# UNITED STATES PATENT AND TRADEMARK OFFICE

APPLICATION NO.	FILING DATE	FIRST NAMED INVENTOR	ATTORNEY DOCKET NO.	CONFIRMATION NO.
10/527,399	04/06/2005	Masahiro Kaizu	Q86775	2802
23373	7590	12/30/2005	EXAMINER	
SUGHRUE MION, PLLC 2100 PENNSYLVANIA AVENUE, N.W. SUITE 800 WASHINGTON, DC 20037				KLAUS, LISA NHUNG
		ART UNIT		PAPER NUMBER
		2832

<b>Office Action Summary</b>	Application No.	Applicant(s)	
	10/527,399	KAIZU ET AL.	
	Examiner	Art Unit	
	Lisa N. Klaus	2832

## **DETAILED ACTION**

FIG. 1 A

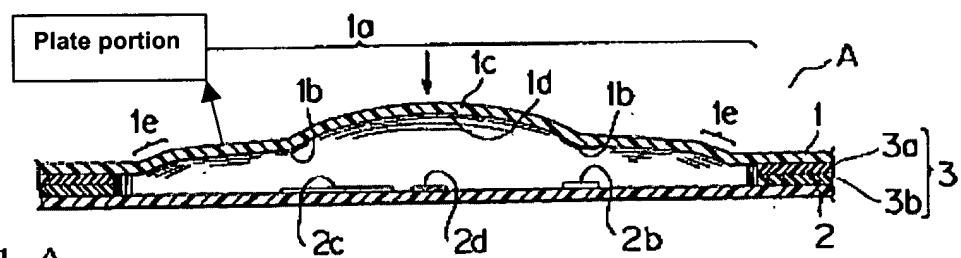
Kawaguchi discloses a dome switch comprising:

- the first leaf spring 1e having conductivity;
- having base fixed relative to a reference surface 3;

- having a plate portion (see the attachment) raised in a direction away from the reference surface 3;
- a second leaf spring 1c having conductivity, being formed on a central portion of the plate portion (see the attachment) raised in a direction away from the reference surface 3;
- wherein when an external force acting toward the reference surface 3 is applied to the second leaf spring 1c, an edge 1b of the central portion comes into contact with the reference surface 3;
- Regarding claim 2, Kawaguchi discloses:
  - the first leaf spring has an angle cross section in a theoretical plane intersecting the reference surface 3;
- Regarding claim 3, Kawaguchi discloses:
  - the first leaf spring 1e and the second leaf spring 1c are disc springs.
